**Comment Response Matrix
for
Nuclear Regulatory Commission (NRC)
Requests for Additional Information (RAIs) on the
Saltstone Disposal Facility Performance Assessment
(SRR-CWDA-2009-00017, Revision 0, dated October 29, 2009)**

Prepared by: Savannah River Remediation (SRR)
Closure & Waste Disposal Authority
Aiken, SC 29808

Prepared for U.S. Department of Energy Under Contract No. DE-AC09-09SR22505

**Figure PA-2.1: Peak Mean Dose to a MOP, Any Sector- Case E
(modified from Figure 5.6-38 in SDF PA)**

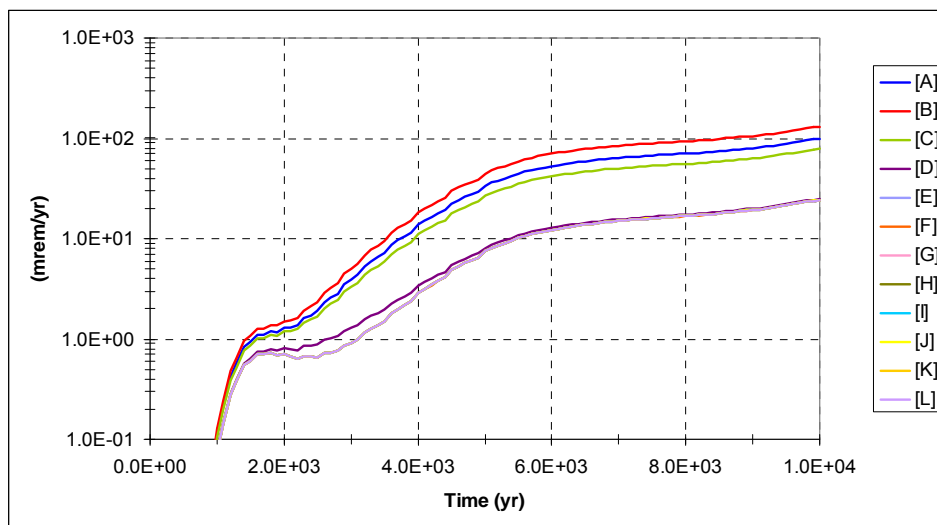
<p><u>PA-2</u></p>	<p>Probabilistic sensitivity analyses were not provided for cases representing bulk saltstone degradation.</p> <p><u>Basis</u></p> <p>Probabilistic sensitivity analyses were performed only for Cases A and C. Although Case C represents a fast flow pathway through saltstone, neither Case A nor Case C represents degradation of the bulk saltstone matrix. Case E, which represents saltstone degradation, was not included in the sensitivity analysis. Dose sensitivities in a case with degraded saltstone are expected to be different from the sensitivities in a case without degraded saltstone. For example, because chemical transitions would be achieved earlier in a case in which bulk saltstone has a greater hydraulic conductivity, parameters affecting the transport of radionuclides sensitive to pH transitions in saltstone may have a greater effect on dose. Similarly, parameters related to slower-moving radionuclides (e.g., plutonium) may have a more significant effect on dose in a case in which more water moves through the bulk saltstone. The sensitivity of these parameters is important to identifying issues that should be tracked during monitoring.</p> <p><u>Path Forward</u></p> <p>Provide a probabilistic sensitivity analysis for a case that reflects saltstone degradation, or explain why the sensitivity analyses performed in the PA are expected to reflect the sensitivities of dose in a case that reflects saltstone degradation. If a new sensitivity analysis is performed, it should be consistent with any modifications made in response to the comments in this document.</p>

<p><u>RESPONSE PA-2:</u></p> <p>This response provides results for the probabilistic uncertainty and sensitivity analysis for the severely degraded saltstone Case E over 10,000 years. Degraded saltstone is assumed to take the form of cracked grout and has been modeled by increasing its hydraulic conductivity to a value of 1.7E-3 cm/sec.</p> <p>As emphasized in SDF PA Section 5.6.4, the results of the uncertainty and sensitivity model are not intended to predict future potential dose for comparison to performance objectives (the SDF PORFLOW model has been used for assessment of peak doses versus performance objectives). Rather, the goal of this SDF modeling is to characterize the context of uncertainty and sensitivity surrounding the PA calculations involving doses to MOP exposed via groundwater. Case E is an extreme case based on the very high hydraulic conductivity value used, which is approximately two orders of magnitude higher than backfill soil. The relative influence of Case E on the composite "AllCases" result is evident by comparing Figure PA-2.1 and Figure PA-2.2 below.</p>

Figure 1: Moisture characteristic curves adapted from the PA and WSRC-STI-2006-00198

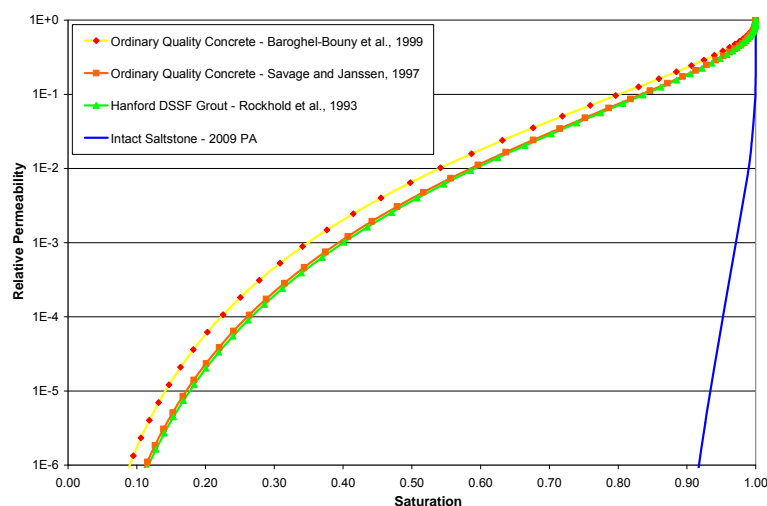
The PA implements curves substantially different from those found in literature. For example, the curves in the PA are significantly different from the curves discussed in *“Hydraulic Property Data Package for the E-Area and Z-Area Soils, Cementitious Materials, and Waste Zones”* (WSRC-STI-2006-00198) (Figure 1). The moisture

<p>characteristic curves discussed in WSRC-STI-2006-00198, which were derived by Rockhold et al. (1993), Savage and Janssen (1997), and Baroghel-Bouny (1999) for different cementitious materials by different methods, all have very similar characteristics. The similarity of the curves is significant because the curve derived by Rockhold et al. (1993) was based on a Hanford double-shell slurry feed (DSSF) grout formulation that is very similar to saltstone (WSRC-STI-2006-00198). Both saltstone and the DSSF grout consist of approximately 47% blast furnace slag, 47% fly ash, and 6% Portland cement with similar salt concentrations (WSRC-STI-2006-00198).</p> <p>Difficulties with experimental methods introduced additional uncertainty into the characteristic curve for saltstone implemented in the PA. The curve developed in <i>"Numerical Flow and Transport Simulations Supporting the Saltstone Disposal Facility Performance Assessment"</i> (SRNL-STI-2009-00115) is based on experiments conducted at the Idaho National Laboratory (INL) which experienced experimental challenges that are not typically encountered in traditional soil and rock testing, as discussed in <i>"Hydraulic and Physical Properties of MCU Saltstone"</i> (WSRC-STI-2007-00649). These challenges resulted in the following non-standard conditions which introduce uncertainty into the results: (i) modification of standard tests, (ii) inconsistent sample preparation, (iii) hydraulic analyses being obscured by the generation of gas within the saltstone samples, (iv) inability to meet the requirements of minimizing the effects of the matrix potential gradient for the samples, (v) limited drainage of the samples, and (vi) the assumption of a residual moisture retention value in the samples that is in contrast with the literature (WSRC-STI-2006-00198; Vanapalli, 1998).</p> <p>Case E and the increased hydraulic conductivity case discussed in Section 5.6.6.7 address the uncertainty in flow through saltstone by assuming it the bulk saltstone to be degraded. Cases B-D and the synergistic case address uncertainty in the flow through saltstone by assuming saltstone to be fractured. However, due to the uncertainty in the characteristic curves for intact saltstone and fractured saltstone, as discussed in this comment and comment SP-4, it is not clear how conservative these sensitivity cases are. In addition, because the base case result is an important factor for compliance determination, it is important to be able to support assumptions about the characteristic curves used for the base case.</p> <p><u>Path Forward</u></p> <p>Provide additional justification for the moisture characteristic curve for intact saltstone implemented in the PA model by addressing the experimental sources of uncertainty described in the basis. Alternately, provide updated results of Cases A, B, C, D, the synergistic case, and the sensitivity case in Section 5.6.6.7 that use a characteristic curve for intact saltstone that is more consistent with results in the literature. Any updated analysis should be consistent with the response to SP-4.</p>

Figure 2: Characteristic curves for the intact and fractured saltstone and concrete as adapted from the 2009 PA and SRNL-STI-2009-00115

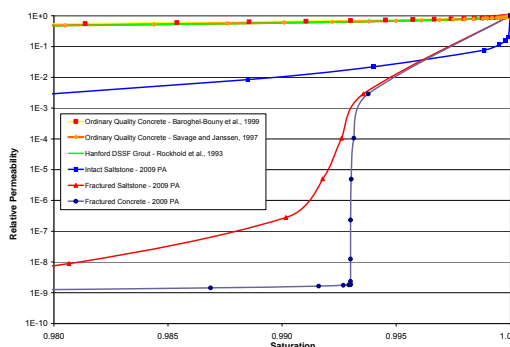
The characteristic curves developed by INL (referred to in SP-3) were also used as the basis for the fractured saltstone and concrete characteristic curves (see Figure 2 below) that were developed in “*Numerical Flow and Transport Simulations Supporting the Saltstone Disposal Facility Performance Assessment*” (SRNL-STI-2009-00115). The authors discuss the use of an analytical approach developed by Or and Tuller (2000) to adapt INL moisture characteristic curves for cracked cementitious materials because experimental characteristic data for cracked vault concrete and saltstone grout are not available (SRNL-STI-2009-00115). However, use of moisture characteristic curves combined with coarse spatial and temporal averaging can result in an inadequate representation of non-equilibrium flow.

Provide additional support for the modeled flow through fractures. Model support could include field observations and laboratory experiments that verify consistency between numerical results and physical measurements.

Figure SP-6.1: Calculated Peclet Number for SDF PA Case A

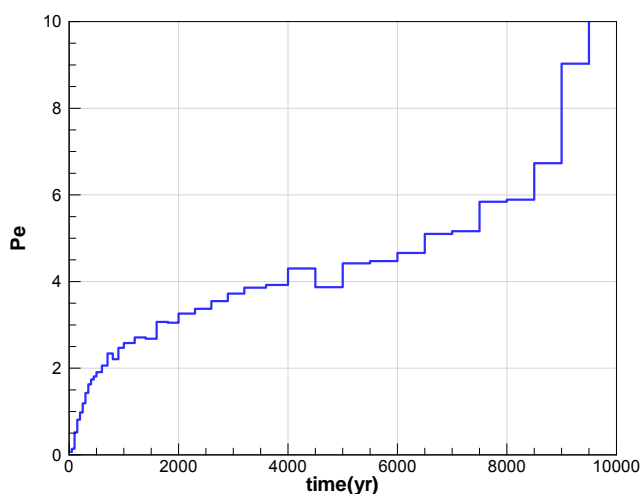
<p><u>SP-6</u></p>	<p>Comment: Additional basis is required for the values of the effective diffusivity of intact and degraded saltstone used in the base case and sensitivity cases.</p> <p><u>Basis</u></p> <p>As discussed in comment SP-1, the effects of degradation of bulk saltstone (as compared to fractures in otherwise intact saltstone) are addressed in sensitivity Case E, in the synergistic case discussed in Section 5.6.6.5, and in an increased saltstone hydraulic conductivity case discussed in Section 5.6.6.7. In each of these cases, the hydraulic conductivity of saltstone is adjusted, but the effective diffusivity is kept constant at the base-case value. Because both the effective diffusion coefficient and hydraulic conductivity are intimately related to pore structure in cementitious materials, it is reasonable to expect that both coefficients would increase as saltstone degrades. The basis for adjusting the hydraulic conductivity in the sensitivity cases but maintaining the effective diffusivity at the base-case value does not appear to be addressed in the PA.</p> <p>In addition, clarification is needed of the basis for the effective diffusivity of intact saltstone. The supporting document "Numerical Flow and Transport Simulations Supporting the Saltstone Disposal Facility Performance Assessment" (SRNL-STI-2009-00115) indicates that the effective diffusivity is based on a comparison to other cementitious materials with similar hydraulic conductivities, but the specific materials used for comparison and the process by which an effective diffusivity value was selected are not provided. Table 4.4-16 of the PA indicates that the effective diffusion coefficient is based on the effective diffusion coefficient of high quality concrete in the supporting document "Hydraulic and Physical Properties of Saltstone Grouts and Vault Concretes" (WSRC-STI-2006-00198). However, the actual value of the effective diffusion coefficient for high quality concretes provided in Tables 6-44 and 6-47 of WSRC-STI-2006-00198 is 5 E-8 cm²/s, which does not match the value of 1.0 E-7 cm²/s used in the PA for saltstone. Furthermore, it is not clear why an effective diffusivity value appropriate for high quality concrete, which has a porosity of 0.11 (PA Table 4.2-16) would be appropriate for saltstone, which has a porosity of 0.58 (PA Table 4.2-16). While the choice of an effective diffusion coefficient of 1.0 E-7 cm²/s is more pessimistic than the value provided for high quality concrete in the supporting document, the basis for the effective diffusivity value chosen should be clarified.</p> <p><u>Path Forward</u></p> <p>Provide a basis for using the effective diffusivity of intact saltstone in the two sensitivity cases that address degraded saltstone listed in the basis or update the sensitivity cases that address degraded saltstone with a value of effective diffusivity that reflects the physical degradation of the wasteform. Clarify the basis for the value of the effective diffusivity of intact saltstone.</p>

<p><u>RESPONSE SP-6:</u></p> <p>While the diffusion coefficient would be expected to increase as the saltstone degrades, the transport is advection dominated except during the first few hundred years after closure as indicated by the Peclet number for Case A for Vault 4 as presented in Figure SP-6.1. As indicated in Figure 5.5-1 in the SDF PA, the peak dose in 10,000 years is in Sector B at year</p>

10,000 and is dominated by releases from Vault 4. At year 10,000 the Peclet number is greater than 10 indicating the dominance of advective versus diffusive transport. Therefore, any change in the diffusion coefficient will not have a noticeable impact on the calculated peak dose results.
